**MECHANICAL ADDENDUM #M-2
NATIONAL DEFENSE, CFB BORDEN, ON
VICKERS KITCHEN AND DINING FACILITY
H-B147-4902/1
MAY 29, 2013**

The following document is hereby made a part of the Contract Documents.

APPROVED:	D.J.
APPROUVE PAR:	R.K.
SCALE:	NTS
PROJECT NO.:	11-233
NUMÉRO DU PROJET:	11-233
DWG NO.:	B147-4902/1 - 446 - MSK-1
NUMÉRO DU DESSIN:	B147-4902/1 - 446 - MSK-1

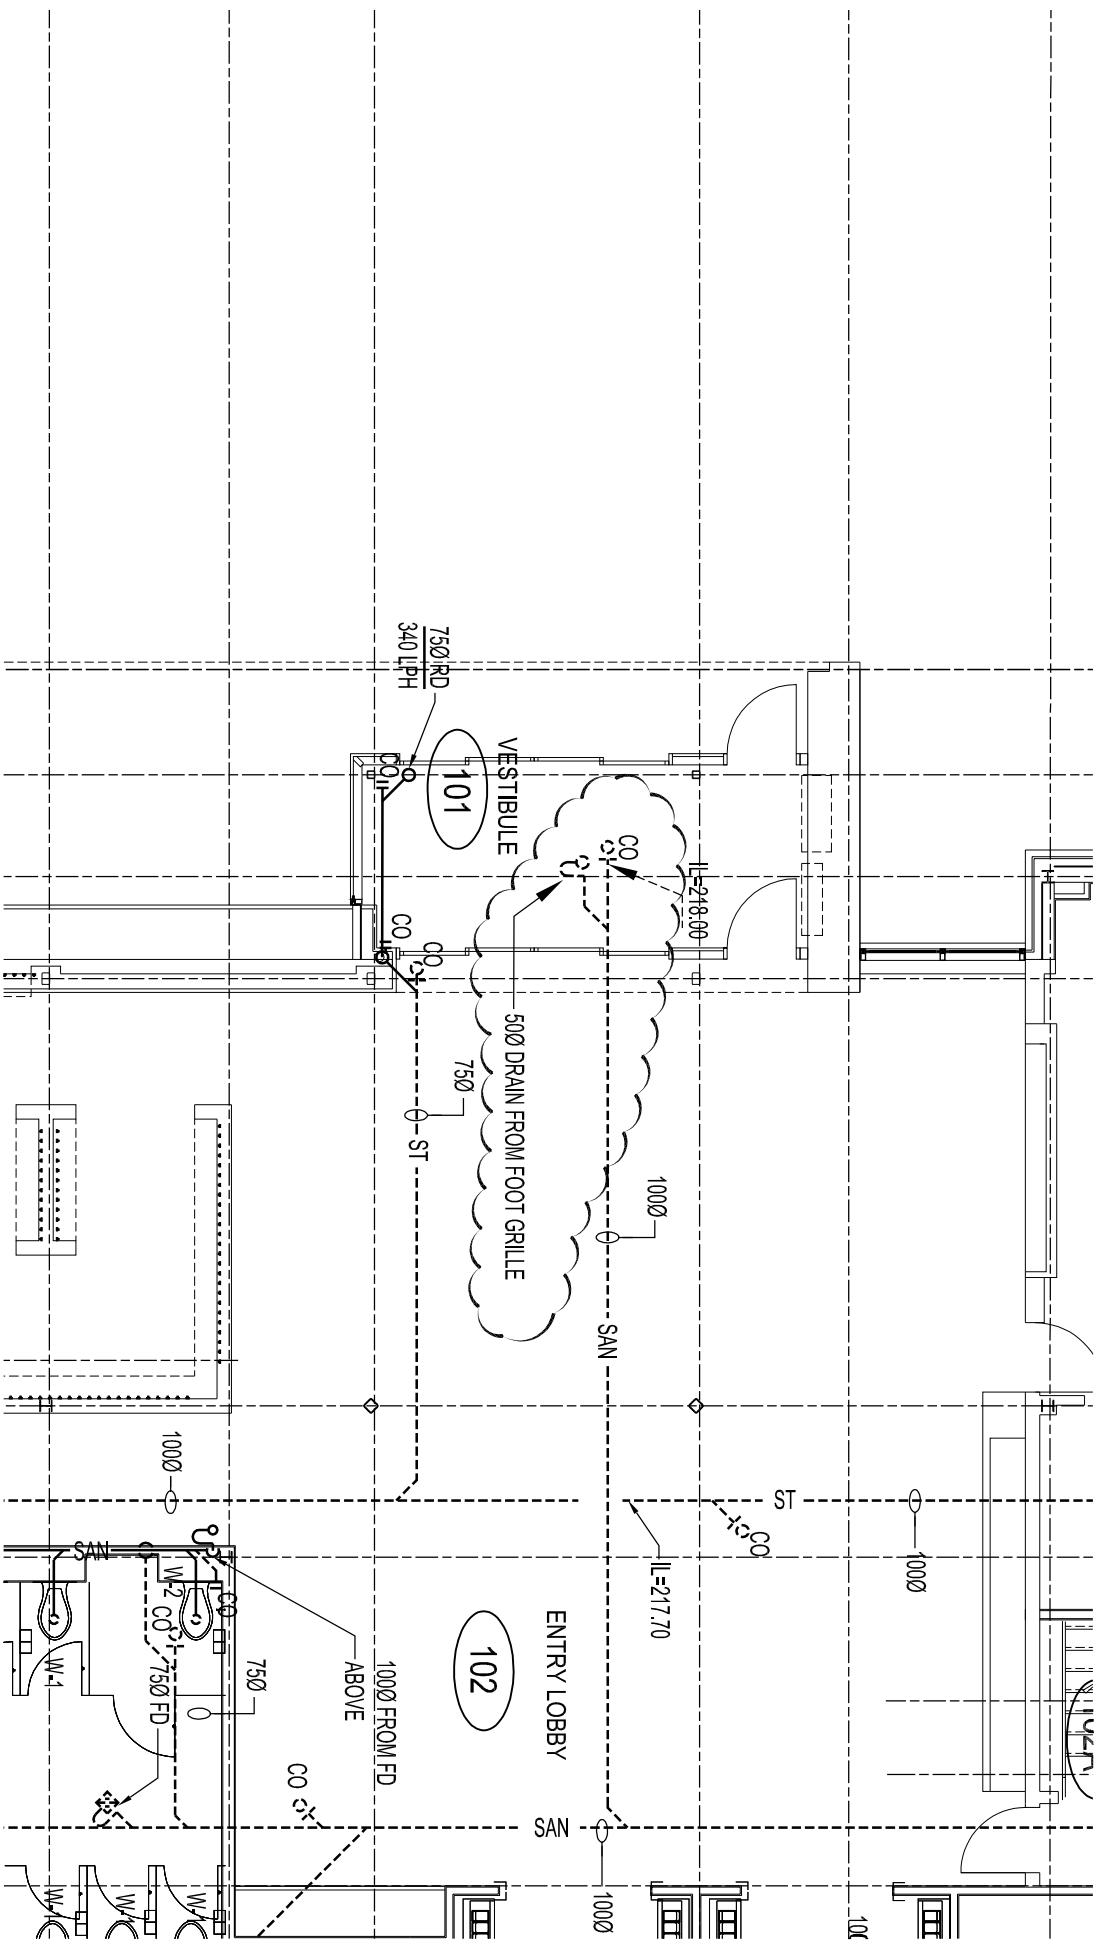
1. Revise the DOMESTIC WATER CONNECTION SCHEMATIC as shown on the attached Sketch MSK-1.
2. Revise the DOMESTIC HOT WATER HEATER PLUMBING SCHEMATIC as shown on the attached Sketch MSK-5.

APPROVED:	D.J.
APPROUVE:	
PAR:	R.K.
SCALE:	1 : 100
ECHELLE:	
PROJECT NO.:	11-233
NUMÉRO DU PROJET:	
DWG NO.:	B147-4902/1 - 422 - MSK-2
NUMÉRO DU DESSIN:

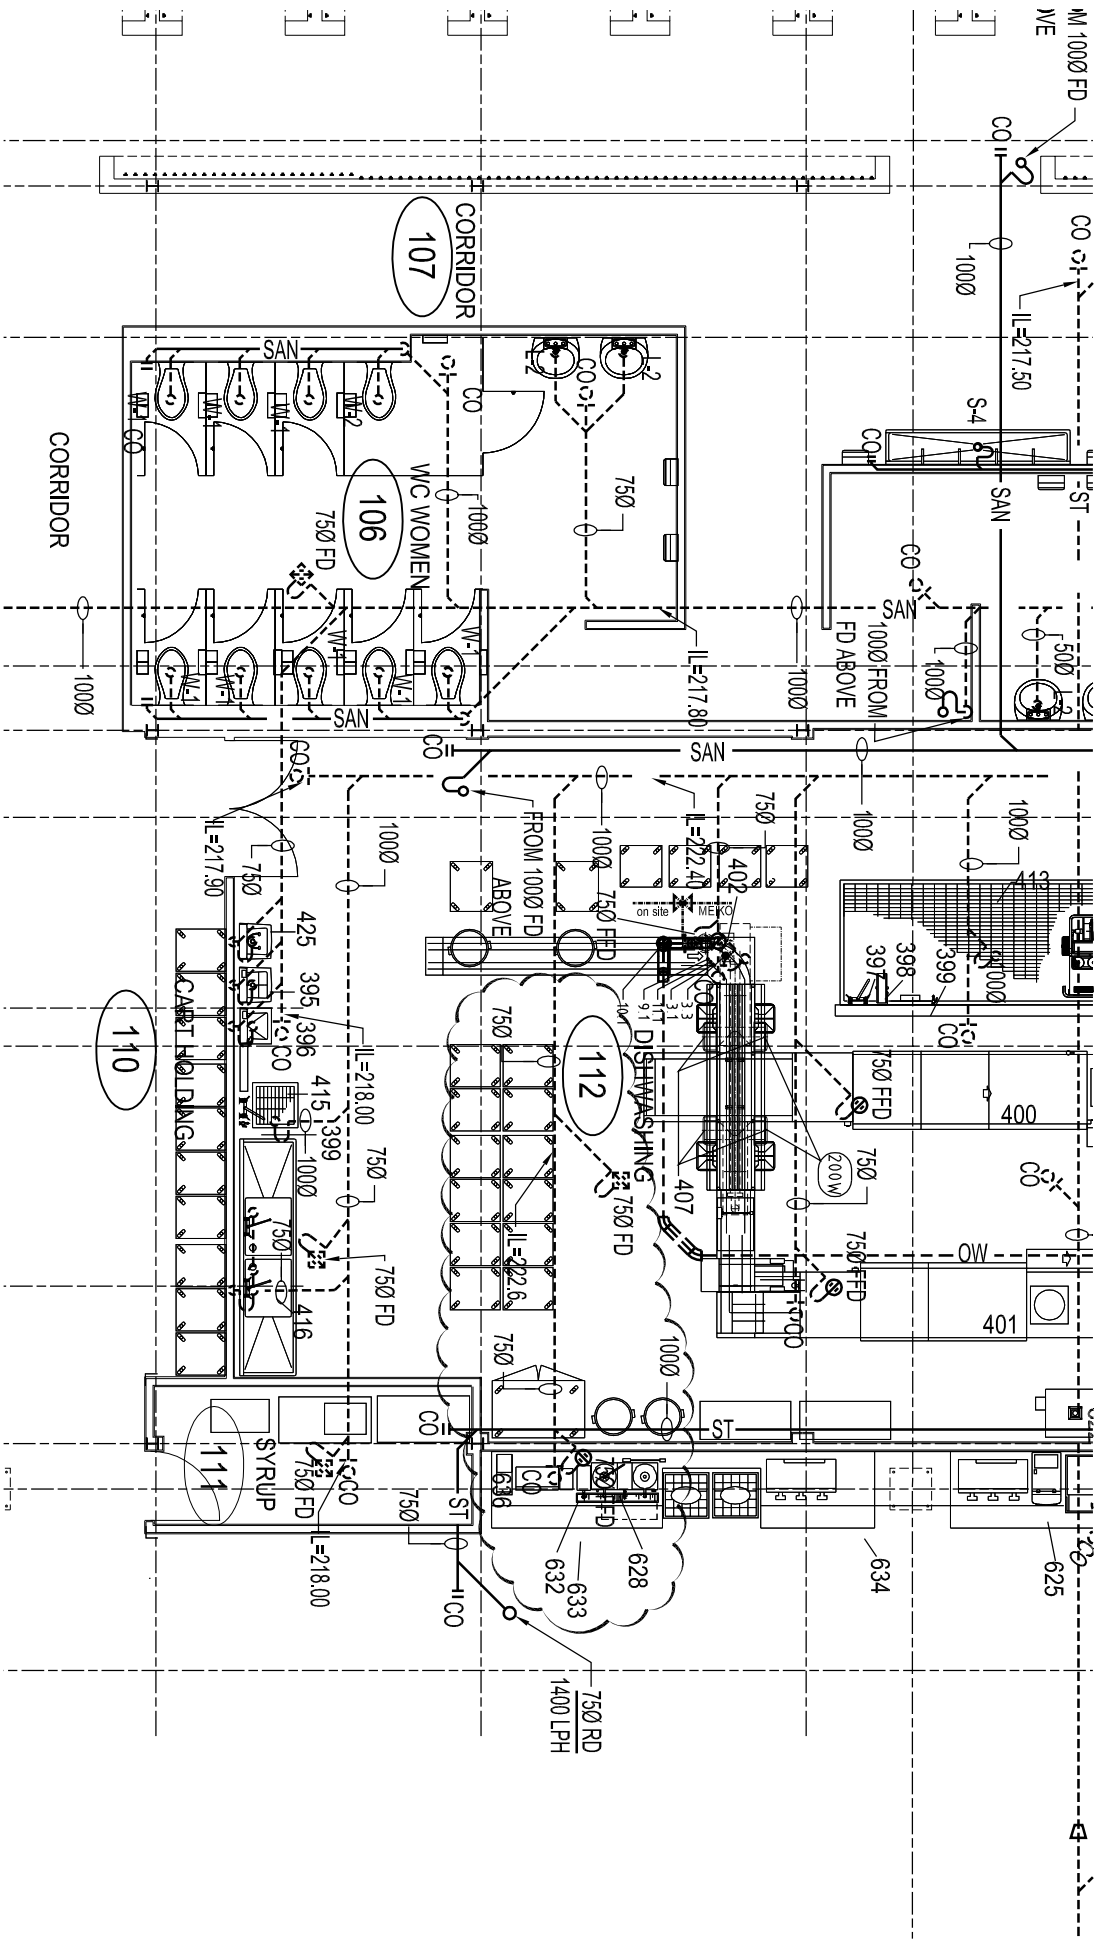
1. Delete the floor drains in the vestibule [101] and revise the sanitary drainage layout as shown on the attached Sketch MSK-2.
2. Revise the sanitary drainage layout to add a funnel floor drain and clean out near kitchen equipment #632 as shown on the attached Sketch MSK-3.
3. Revise the rain water drainage layout as shown in the attached Sketch MSK-11.

DWG NO.: B147-4902/1 - 433 - MSK-4
NUMÉRO DU DESSIN:

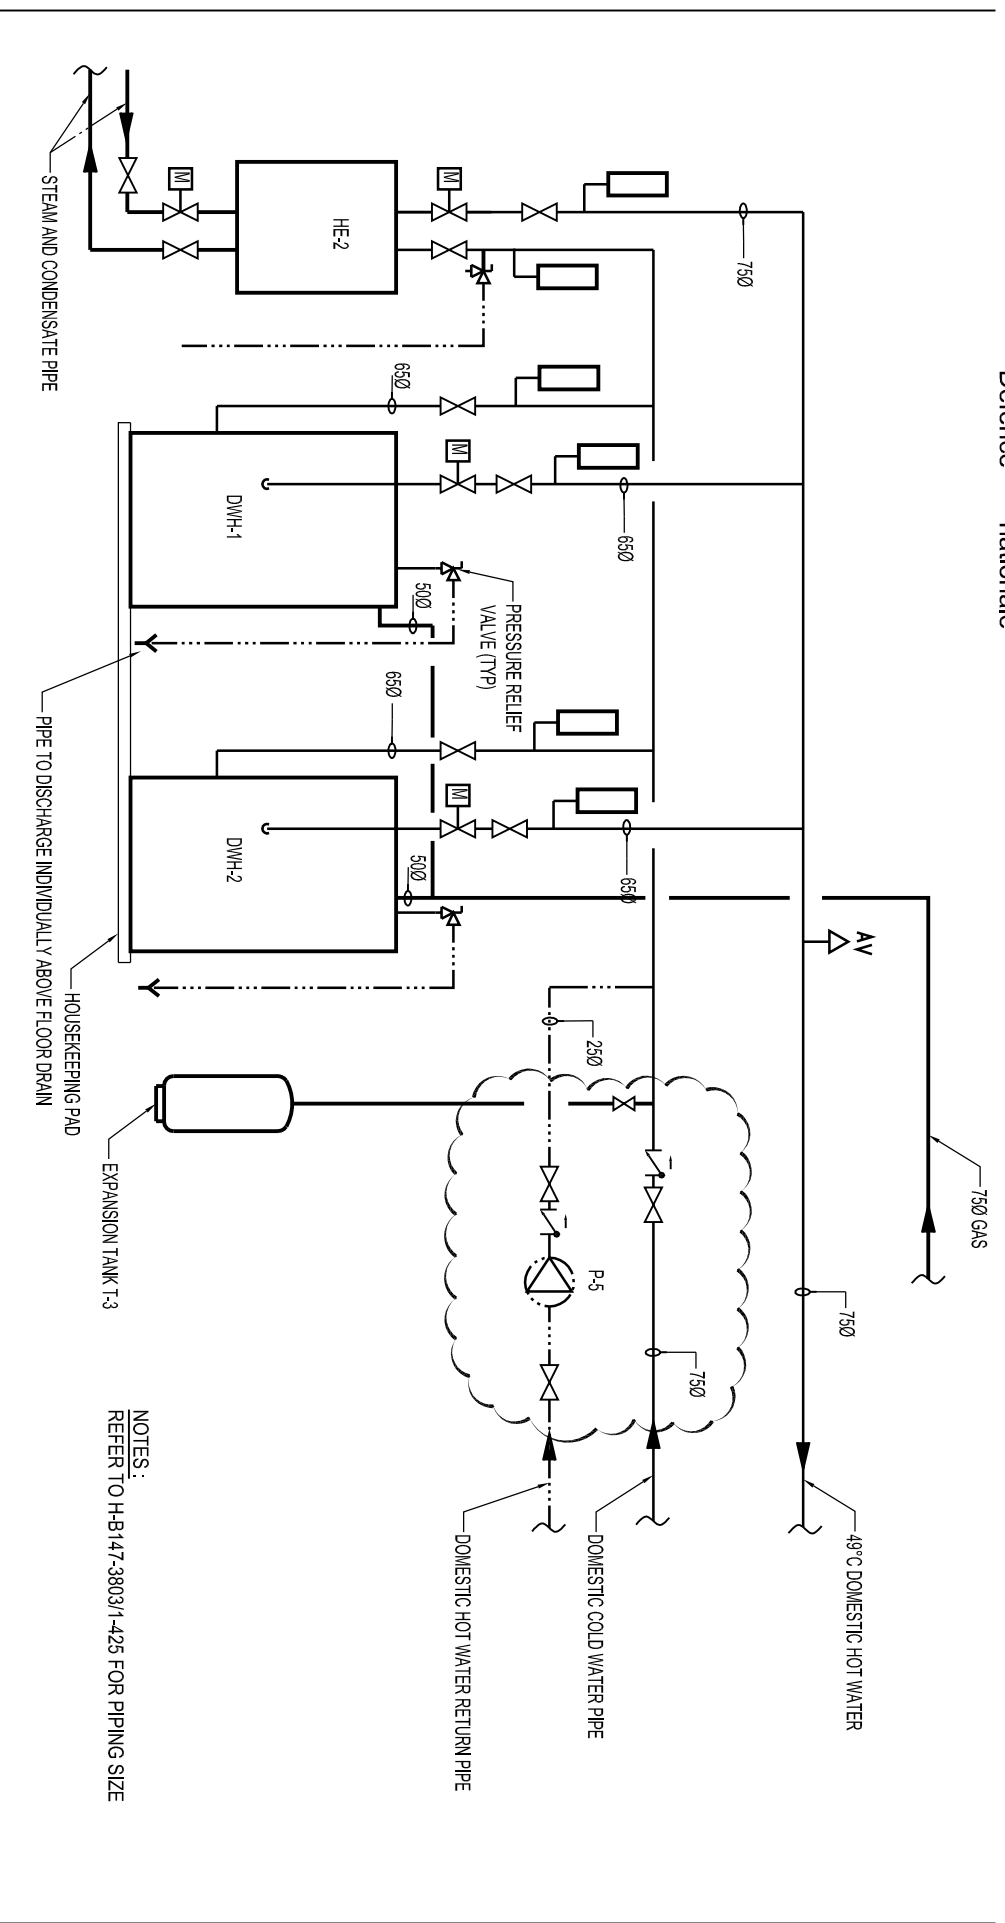
1. Add heat tracing to the condensate drain pipe as shown on the attached Sketch MSK-4.

DWG NO.:
NUMÉRO DU DESSIN: B147-4902/1 - 441 - MSK-6

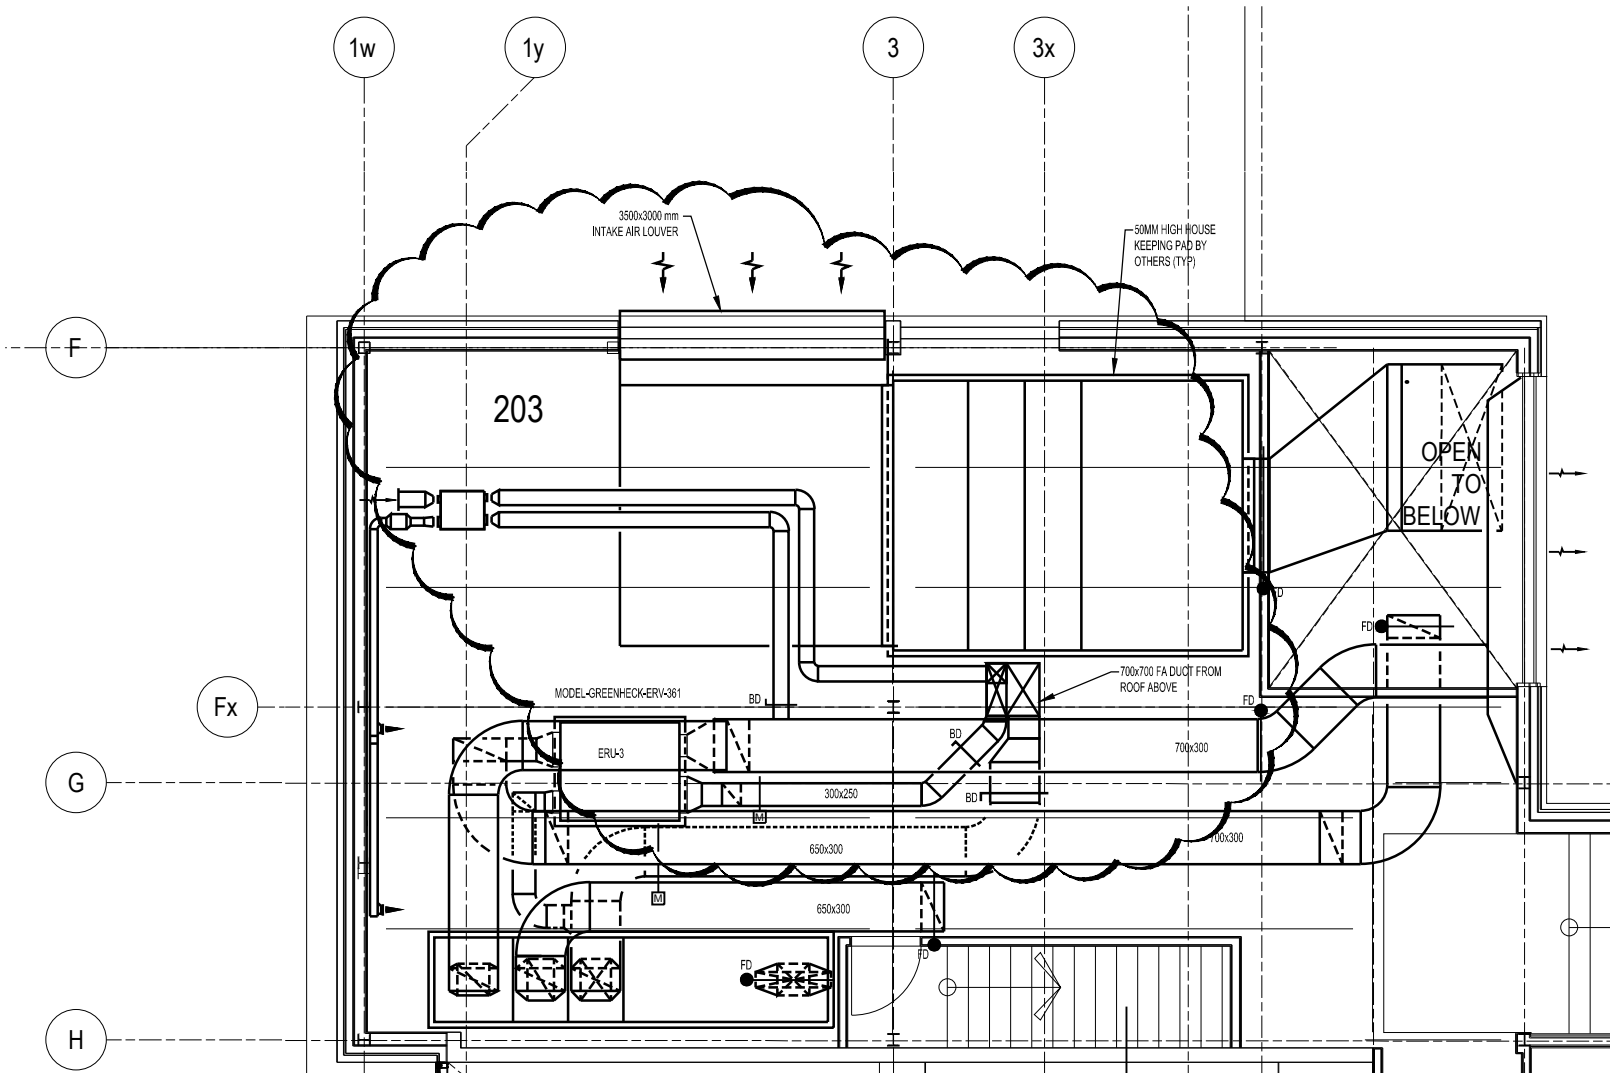
1. Delete the fresh air duct immediately downstream of the branch take-off to ERU-1 as shown on the attached Sketch MSK-6.
2. Provide fresh air duct connections from the roof penthouses to AHU-1, AHU-2, AHU-4 and ERU-2 as shown on the attached Sketch MSK-6. Each louvered penthouse shall be 500mm high.

APPROVED:	D.J.	
APPROUVÉ PAR:	R.K.	
SCALE:	NTS	
ÉCHELLE:	NTS	
PROJECT NO.:	11-233	1 of 1
NUMÉRO DU PROJET:		
DWG NO.:	B147-4902/1 - 440 - MSK-7	
NUMÉRO DU DESSIN:

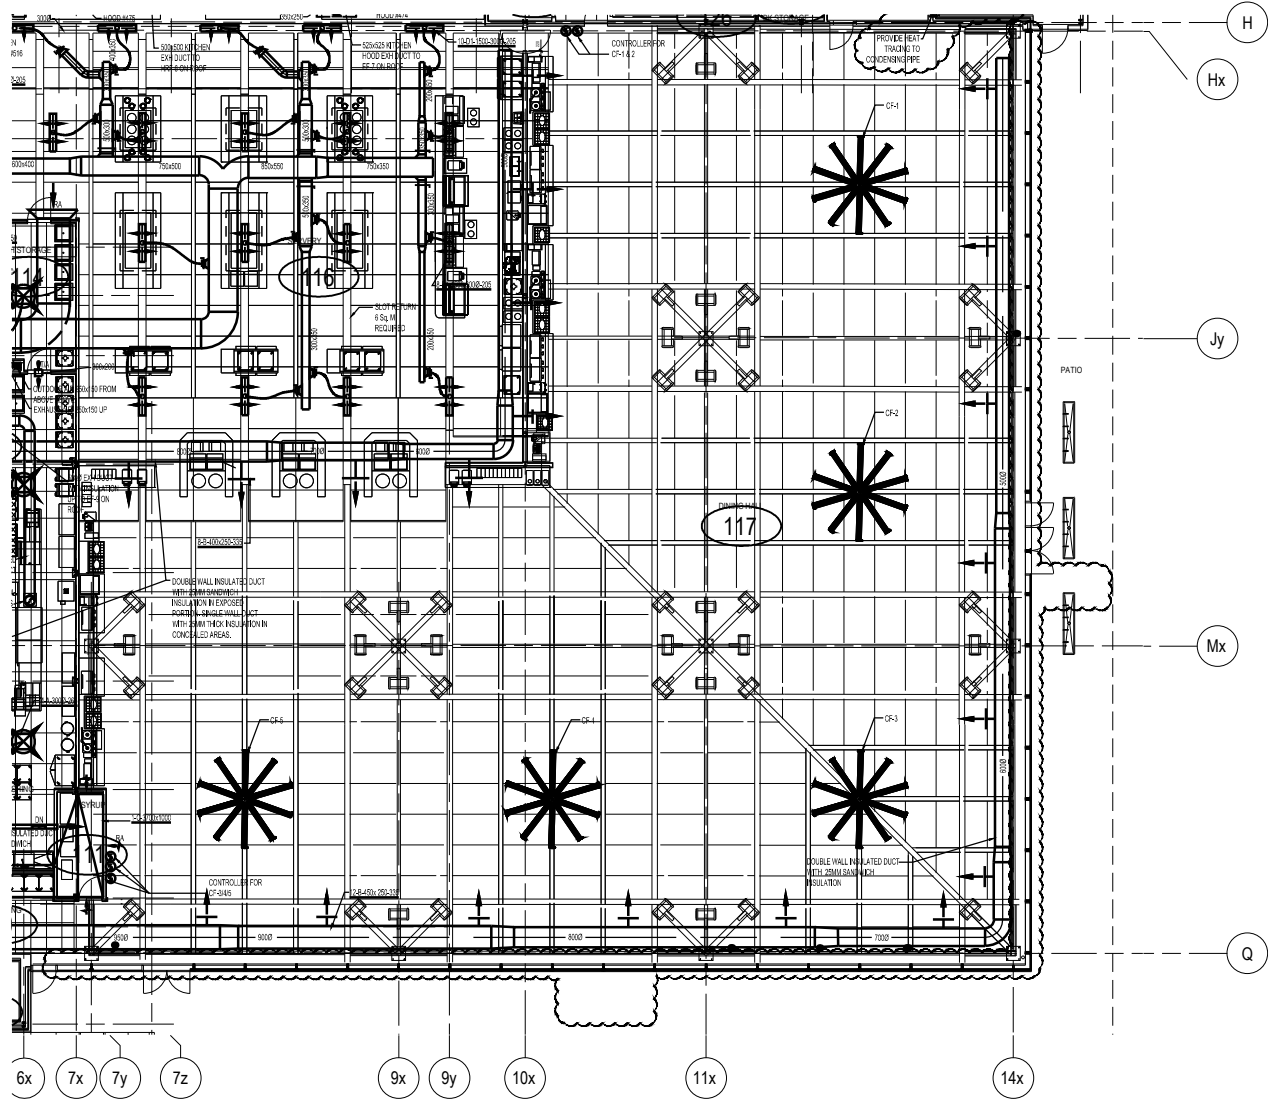
1. Revise the fresh air duct layout in the mechanical room as shown on the attached Sketch MSK-7.
2. Provide fresh air intake louvre as shown on the Sketch MSK-7.

APPROVED:	D.J.
APPROUVÉ	
PAR:	R.K.
SCALE:	NTS
ÉCHELLE:	
PROJECT NO.:	11-233
NUMÉRO DU PROJET:	
DWG NO.:	
NUMÉRO DU DESSIN:	B147-4902/1 - 435 - MSK-8

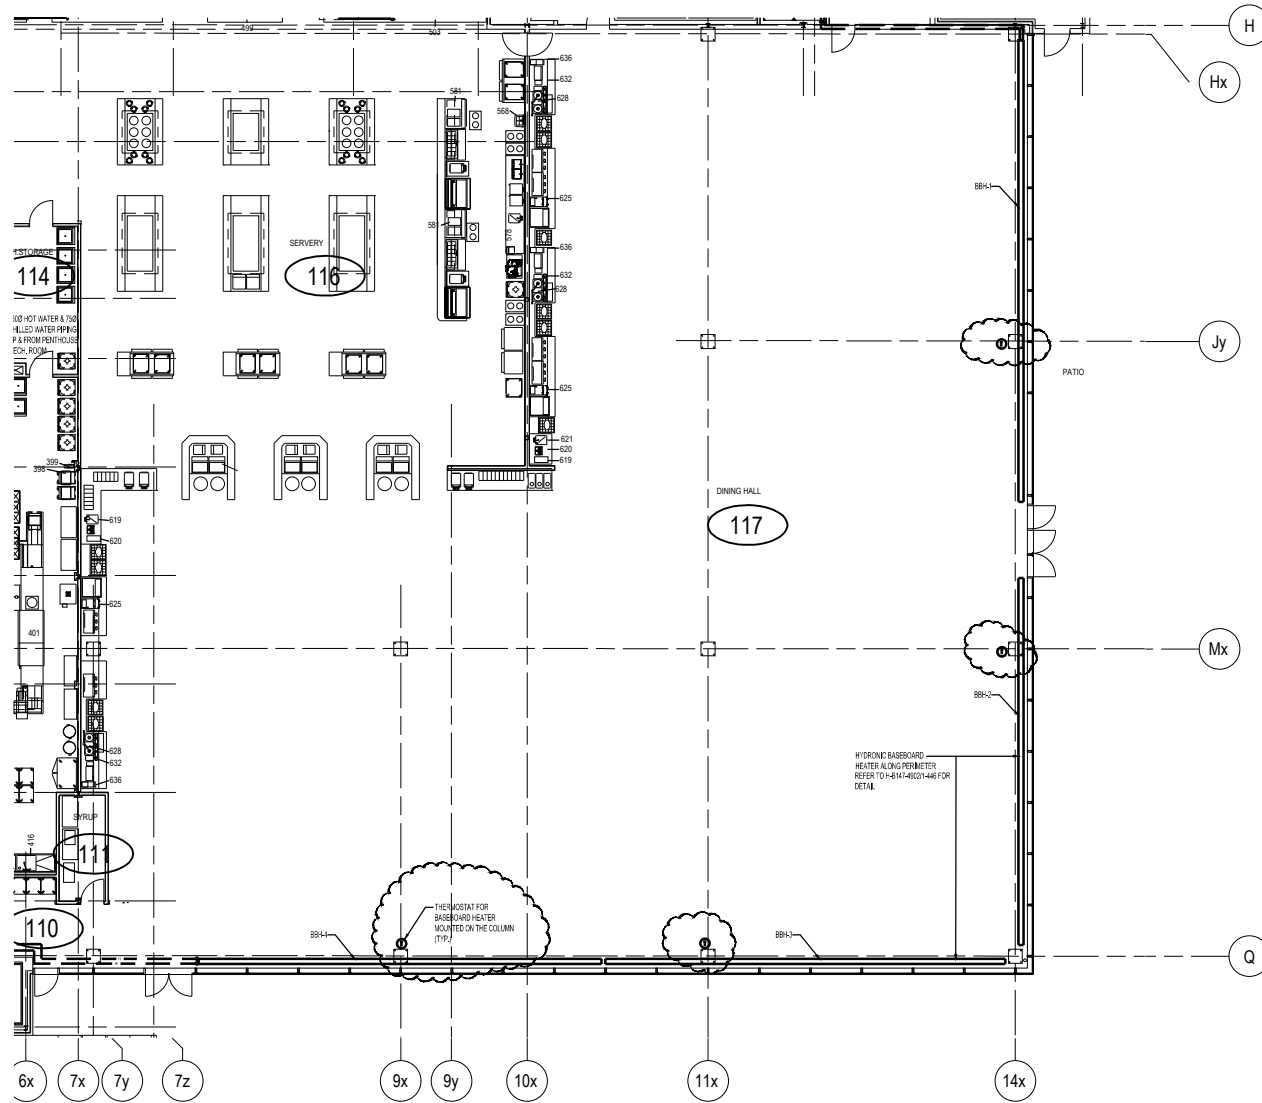
1. Delete the hydronic radiant panel shown in the room DINING HALL [117]. See the attached Sketch MSK-8.
